Attached please find the East Bay Municipal Utility District's comments on the Draft BDCP and BDCP Draft EIR/EIS.

SUBJECT: Comments on the Bay Delta Conservation Plan and Environmental Impact Report/Environmental Impact Statement

Draft EIR/EIS is Incomplete and Inadequate

Figure 1. Projected Inflow to Trinity, Shasta, Oroville, and Folsom Reservoirs – NAA, NAA-ELT and NAA-LLT

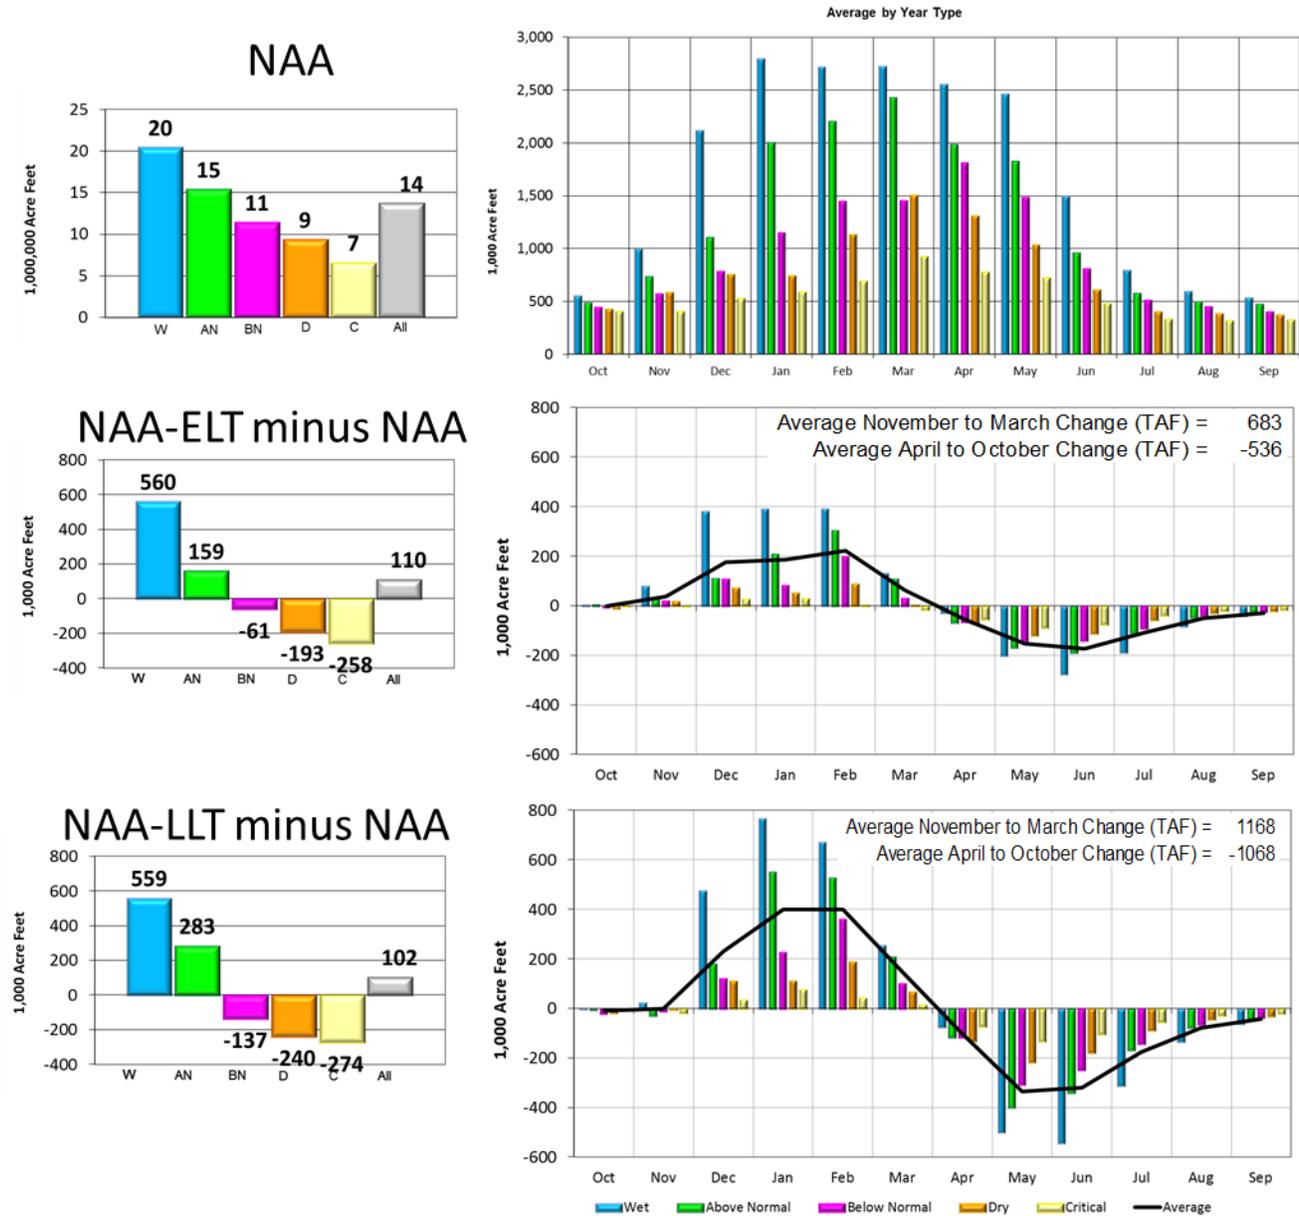
The significance of changed hydrology between the three without project baselines is illustrated in Figure 1 below. The figure illustrates the projected combined inflow of Trinity, Shasta, Oroville, and Folsom Reservoirs under the three NAA baselines. Numerous modeling projections for climate change have been developed, and in this BDCP group of Scenarios Trinity, Shasta, and Oroville inflow are projected to increase overall, but with a

In our opinion, the CalSim II depicted operations that incorporate climate change are not reasonably foreseeable and do not represent a likely future operation of the CVP/SWP. Although an argument is typically made that these study baselines will be used in a comparison analysis with Project Alternatives tiering from these baselines, we believe that the depicted operations do not represent credible CVP/SWP operations and we have no confidence in the results and they are inappropriate as the foundation of a Project Alternative. As such, although the modeling approach may provide a relative comparison between equal foundational operations, we are apprehensive to place much confidence in the computed differences shown between the NAA and Project Alternative Scenarios.

For upstream CVP and SWP reservoirs the assumed shift of inflows due to climate change (Figure 1) along with a continuing need to satisfy exports demands significantly affects carryover storage. The CVP and SWP simply cannot satisfy water demands and regulatory criteria imposed on them in the NAA-ELT and NAA-LLT modeling scenarios.

Figure 2. Projected Shasta Reservoir Carryover Storage, NAA, NAA-ELT and NAA-LLT

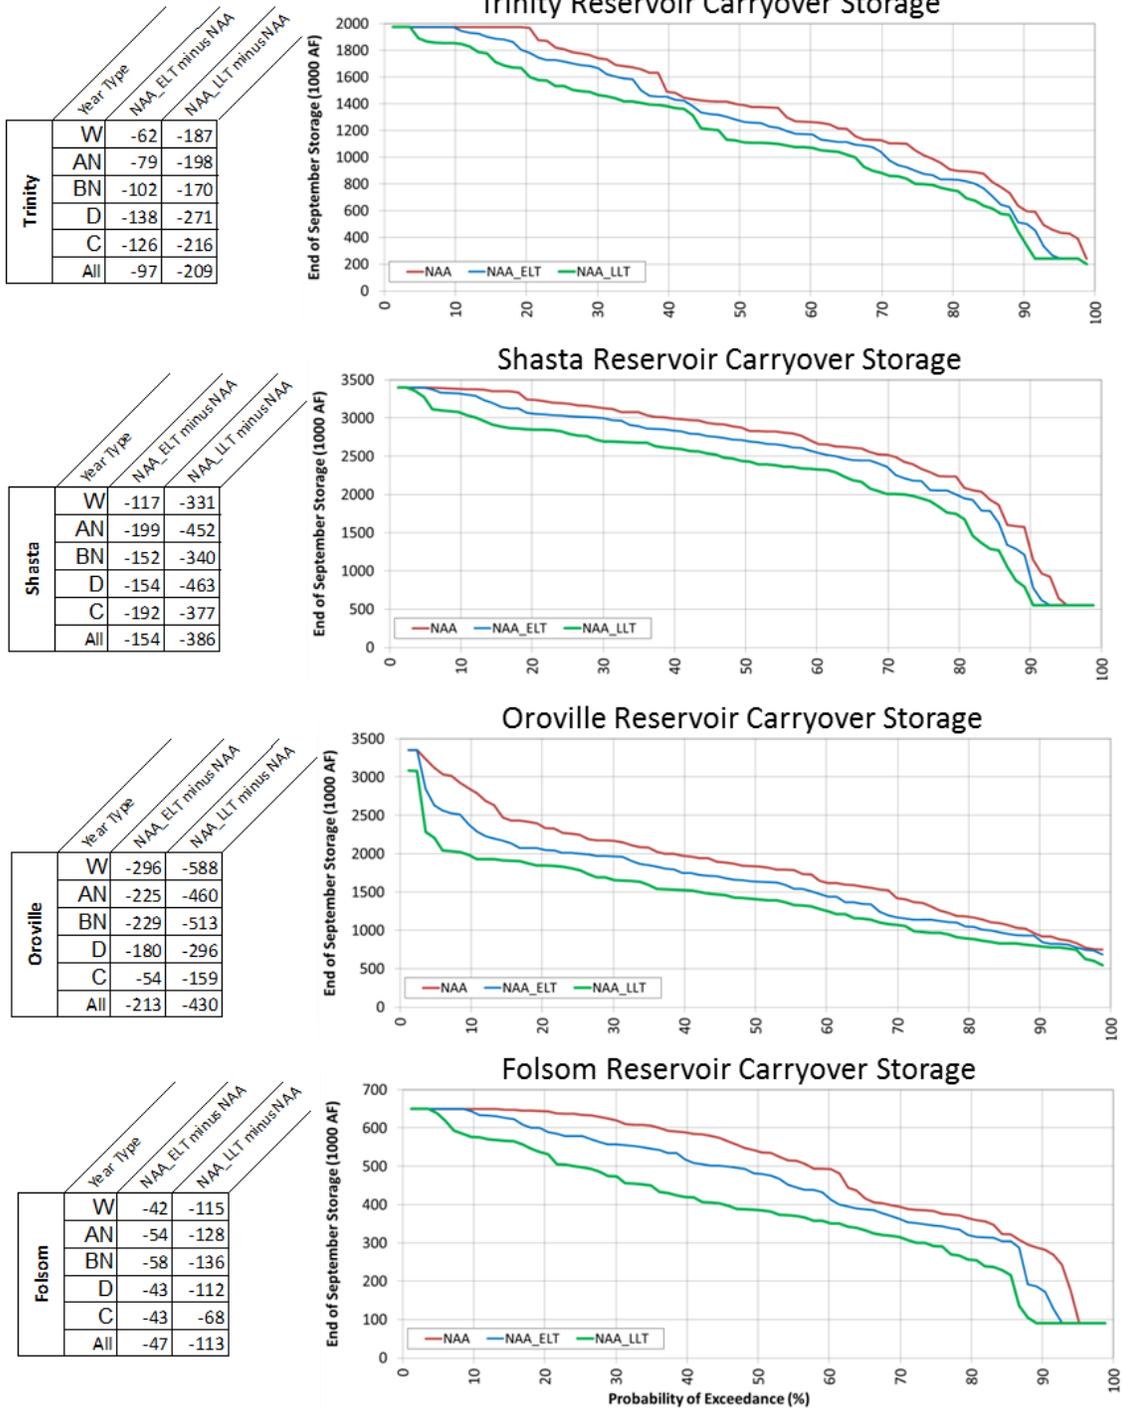
Figure 2 illustrates the typical change in carryover storage as shown for Trinity, Shasta, Oroville, and Folsom Reservoirs. The relatively high frequency (approximately 10% of time) of minimum storage occurring at CVP reservoirs illustrates our questioning of credible operations in the studies.

Figure 3. Projected Inflow to Millerton Lake –NAA, NAA-ELT and NAA-LLT

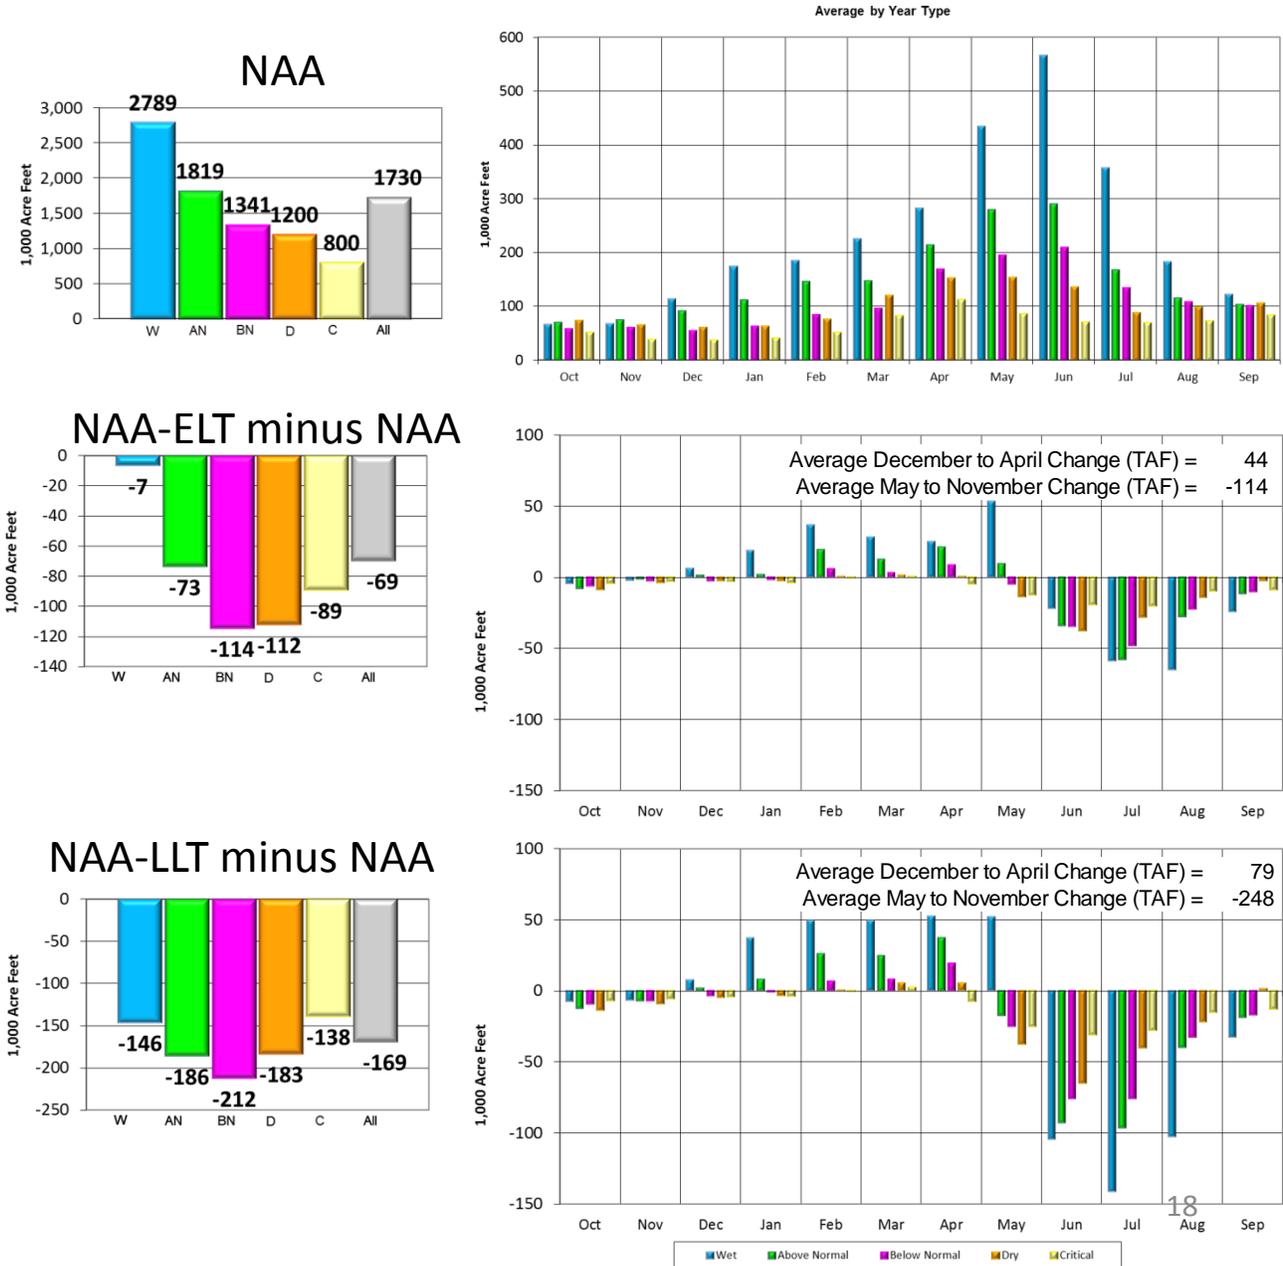
San Joaquin Valley reservoirs are depicted with an overall decrease in annual runoff with some shifting of runoff from spring to winter, but mostly just decreases in spring runoff due to a decline in snowmelt runoff during late spring⁵. Figure 3 illustrates the assumed effects of climate change upon inflow to Millerton Lake.

Figure 4. Millerton Reservoir Carryover Storage, NAA, NAA-ELT and NAA-LLT Scenarios

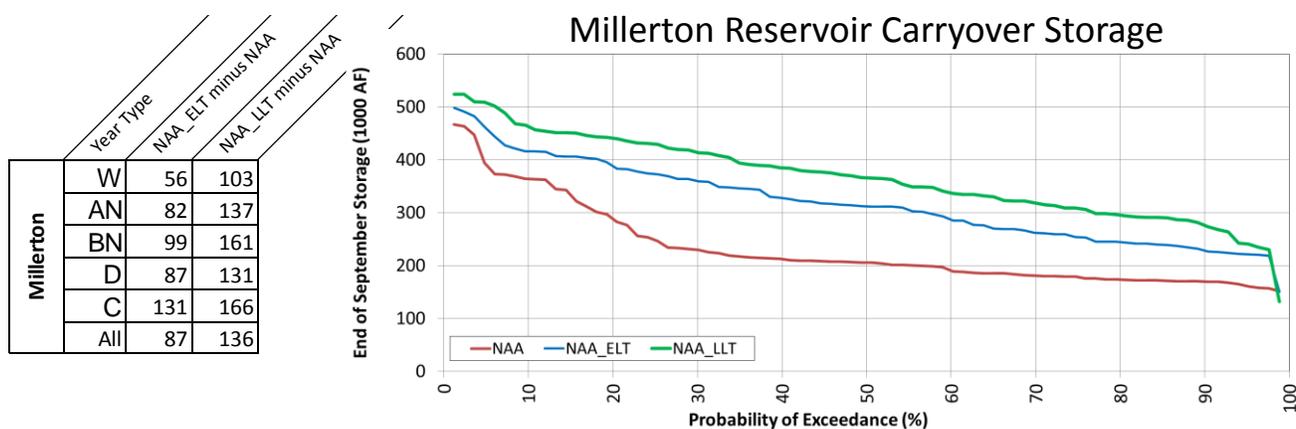
Inflow to Millerton Reservoir in this version of CalSim is input in three separate time series for purposes of depicting the hydrology of potential upper basin reservoirs. Climate change hydrology was inconsistently incorporated at Millerton Reservoir and misapplied to the water supply and flood control operations. The result is an unrealistic operation for river releases and canal diversions. Figure 3 illustrates the projected ELT and LLT changes in Millerton Reservoir inflow incorporated in these studies. On face value of the input data, regardless of Friant Dam river release assumptions the effect of climate change at Millerton Lake will affect water deliveries.

Evidence of the inconsistent inflow problem is shown in the result for the comparison of carryover storage of Millerton Reservoir under the NAA, NAA-ELT, and NAA-LLT Scenarios (Figure 4). Carryover storage is higher in the ELT and LLT Scenarios due to climate change effects to inflow incorporated in reservoir operations but not in the computation of water supply deliveries. Thus, water deliveries are suppressed and the reservoir ends the year with greater storage.

Figure 12. Temperature Exceedance Sacramento River at Bend Bridge Existing, No Action Alternative, ELT

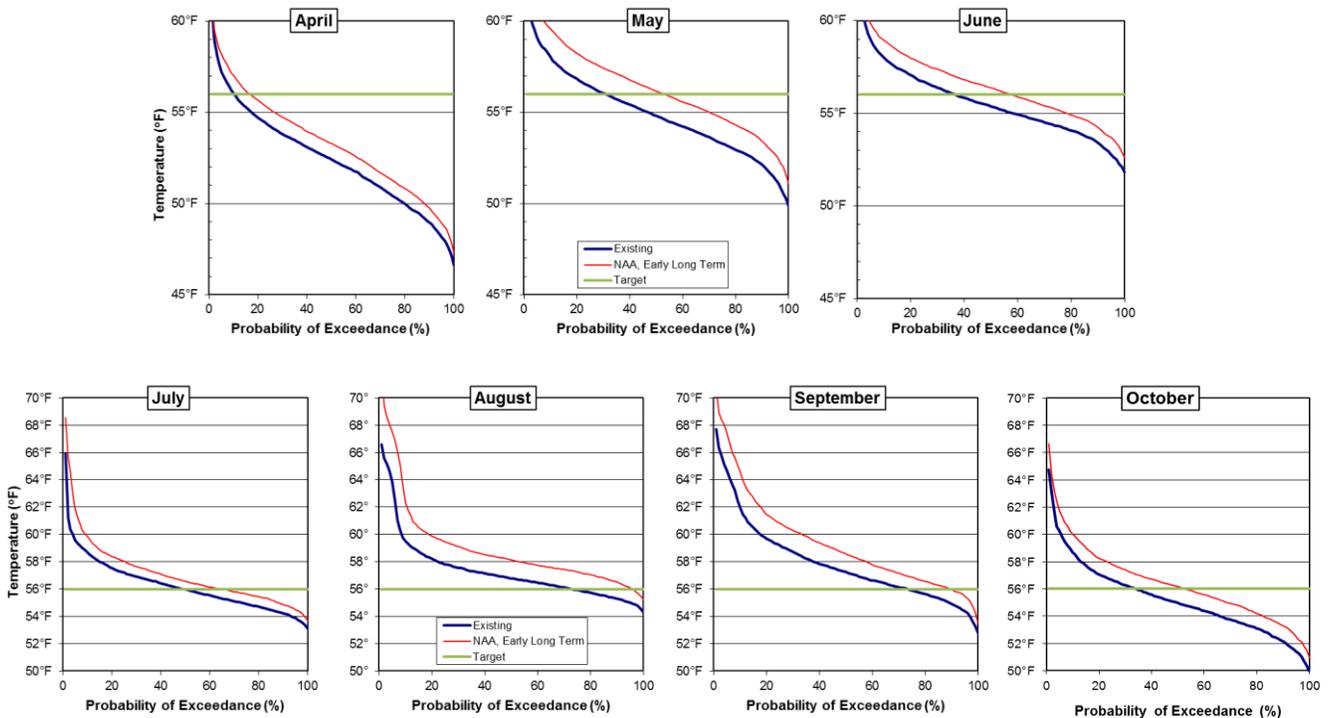
The increase in equilibrium temperatures combined with decreases in storage would lead to water temperature conditions that would likely not achieve the assumed objectives. Figure 12 and Figure 13 illustrate an increase in the probability that a water temperature target of 56°F would be exceeded at Bend Bridge under both the NAA-ELT and NAA-LLT Scenarios. The probability of exceedance increases approximately 5% to 20% depending on the month for the NAA-ELT Scenario and approximately 10% to 40% for the NAA-LLT Scenario.

Figure 19. NDD, Bypass Requirement, Bypass Flow, and Excess Sacramento R. flow for Alt 4-ELT

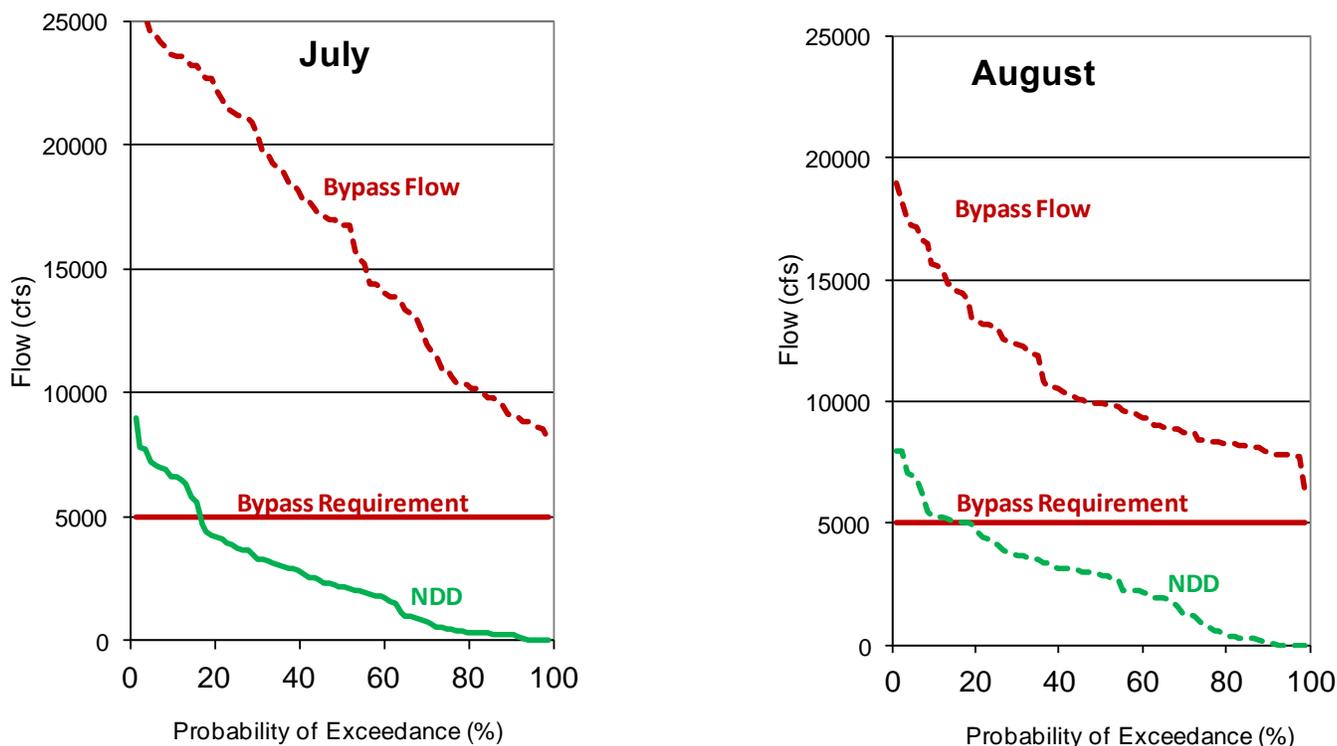
Sacramento River flow below the North Delta Diversion (NDD) must be maintained above the specified bypass flow requirement, therefore the NDD rates are limited to the Sacramento River flow above the bypass requirement. Due to an error in CalSim II that specifies an unintended additional bypass requirement, modeling performed for the BDCP EIRS often bypasses more Sacramento River flow than is specified in the BDCP project description. This error has been fixed in the most recent public releases of CalSim II, but BDCP modeling has not been updated to reflect these fixes. Figure 19 contains exceedance probability plots showing the Sacramento River required bypass, Sacramento River bypass flow, NDD, and excess Sacramento River flow to the Delta as modeling for BDCP. As can be seen in Figure 19, the bypass flow is always above the bypass requirement in July and August. The BDCP version of CalSim sets a requirement for Sacramento River inflow to the Delta needed to satisfy all Delta flow, quality, and export requirements, this requirement should be removed when modeling the NDD.

Figure 22. Alt 4-ELT North Delta Diversion Versus South Delta Diversion for July, August, and September

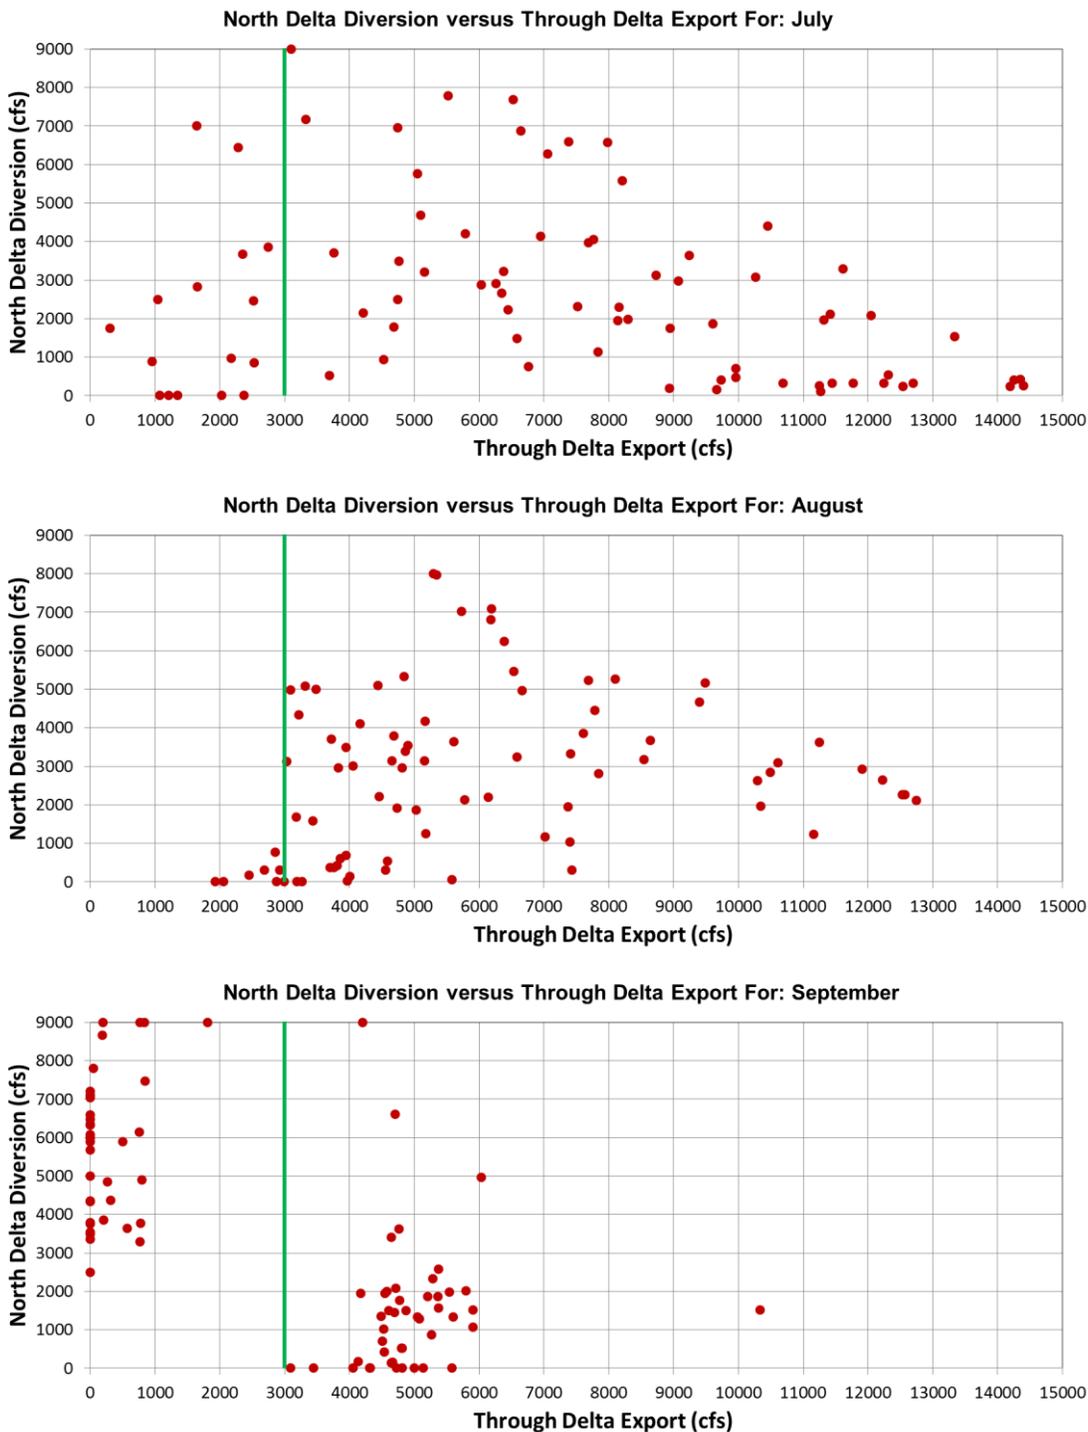
Figure 22 contains figures for July, August, and September for Alt 4-ELT that plot NDD against SDD. In the months of July to September SDD are occasionally very high, exceeding 14,000 cfs in July, with minimal NDD. This occurs due to outdated model code that imposes an instream flow requirement in Sacramento River flow below Hood in excess of the bypass criteria prescribed in the BDCP. There are numerous occurrences when bypass flows prescribed in the BDCP are exceeded and SDD are higher than expected. On the other hand, there are also many times when NDD are above minimum pumping levels and SDD are below the BDCP prescribed 3,000 cfs threshold indicated by the green line in Figure 22. For unknown reasons, the model code requiring SDD to be greater than 3,000 cfs before NDDs occur from July through September is deactivated in the BDCP modeling of this Alternative.
